Annex I - Coastal Access – Lulworth Cove to Kimmeridge Bay

Representations on LCK 1: Lulworth Cove to Lulworth Ranges Gates West & LCK 3: Lulworth Ranges Gates East to Gaultier Gap, Kimmeridge and Natural England's comments

February 2026

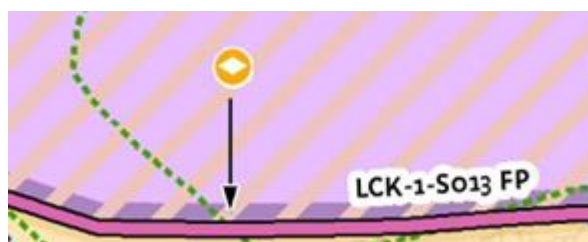
The present situation regarding public rights of way at Lulworth is very confusing with a number of paths still shown on the definitive map being lost to cliff falls and erosion. A wall has been built over the path originally used by the SWCP, but it is still on the definitive map. We will be writing to Dorset Council about this separately.

We are aware of mapping issues on the OS Map (as also raised by The Ramblers) however correcting these mapping anomalies are not within the remit of NE to resolve. We are aware that the matter has been raised with Dorset Council.
